Subject: N192219210 - Service Update Transmission Torque Converter

Models: 2019 Chevrolet Sonic

Service Update N192219210 Transmission Torque Converter

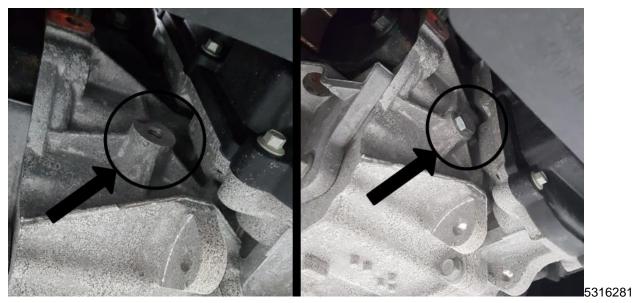
Condition	Certain 2019 model year Chevrolet Sonic vehicles may have a torque converter housing hole drilled too deep.
Correction	Dealer to insert an adhesive coated bolt to prevent external leaks.

- 1. Lift the vehicle. Refer to Lifting and Jacking the Vehicle in SI.
- 2. Locate the threaded bolt hole in the front of the transmission as shown above.
- 3. Install the provided bolt in the hole and torque to 19Ft-lbs (25N-m).
- 4. Lower the vehicle. Refer to *Lifting and Jacking the Vehicle* in SI.
